UNITED STATES PATENT AND TRADEMARK OFFICE

APPLICATION NO.	FILING DATE	FIRST NAMED INVENTOR	ATTORNEY DOCKET NO.	CONFIRMATION NO.
10/709,973	06/10/2004	Andrew Scott Argersinger	GEMS 0242 PUS	3972
27256	7590	10/31/2007		
Dickinson Wright PLLC 38525 Woodward Avenue Suite 2000 Bloomfield Hills, MI 48304			EXAMINER RAMIREZ, JOHN FERNANDO	
			ART UNIT 3737	PAPER NUMBER
			MAIL DATE 10/31/2007	DELIVERY MODE PAPER

Office Action Summary

DETAILED ACTION

Fig. 12

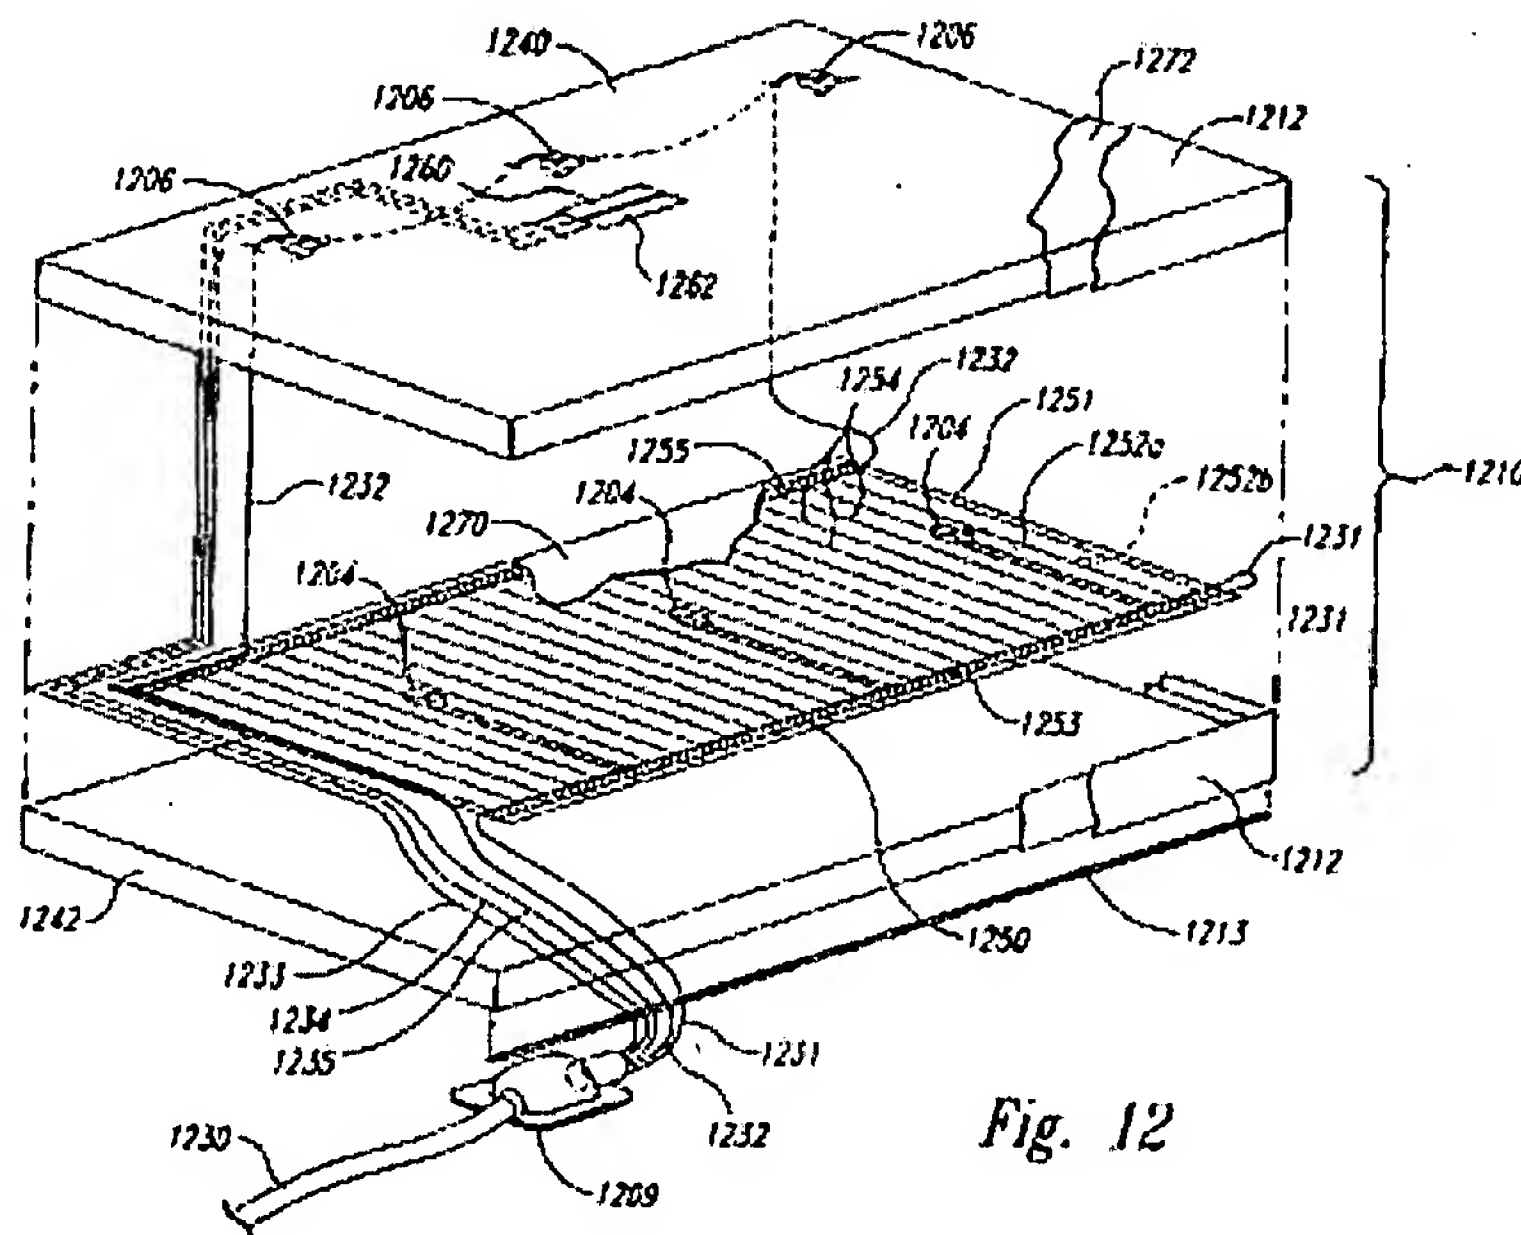
The Wyatt et al. patent teaches, a thermo sensor assembly positioned to monitor temperature at the patient exposure surface, a logic (fig. 1,120) that is in communication with the thermo sensor (fig. 12,1260, 1262) assembly and the thermo generating element (fig. 12, 1250), and said logic (fig. 1, 120) adapted to remove power from the thermo generating element (col. 18, lines 27-46).

Fig. 25

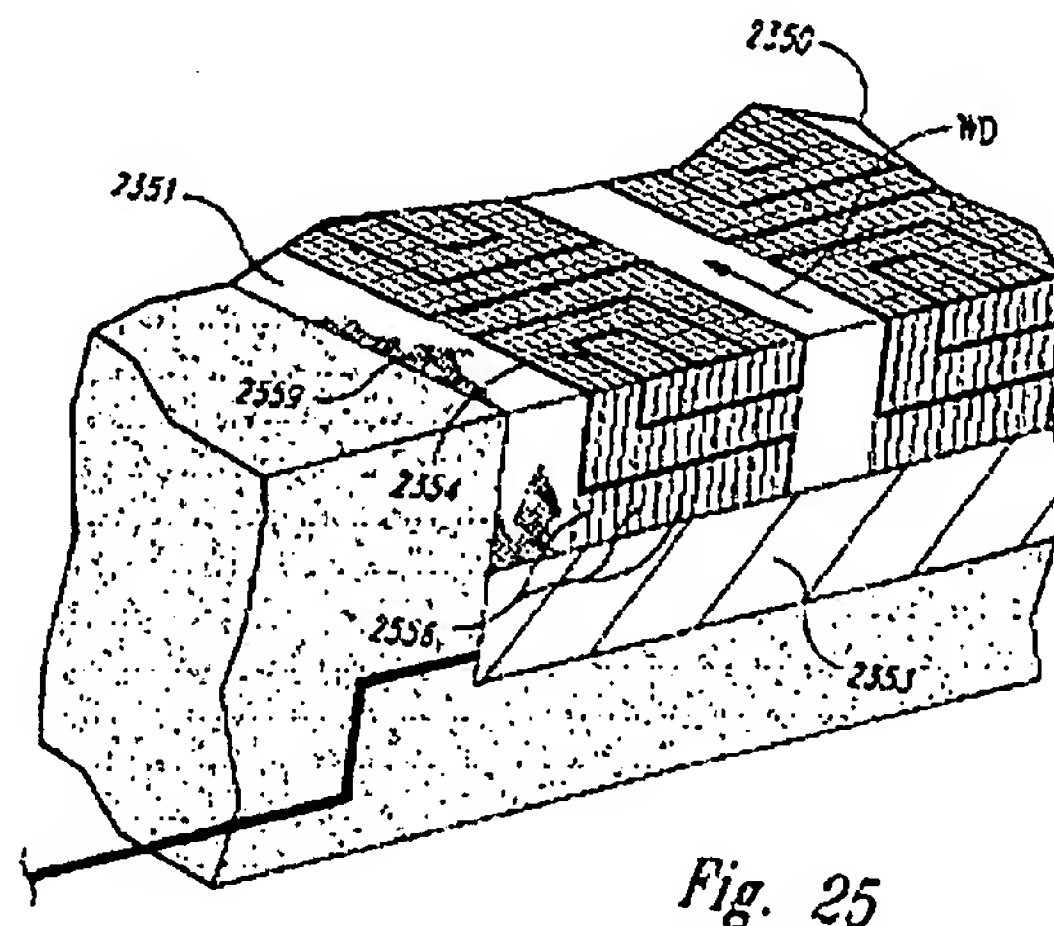
The Wyatt et al. patent Shows in figures, 24A-D, a thermo generating element that comprises: a heater array (see Fig. 25) comprising a conductive polymer coating bonded to a film (col. 35, line 33-45) base and a protective film layer laminated to said film base, and wherein said conductive polymer coating comprises carbon flakes and a polymer.
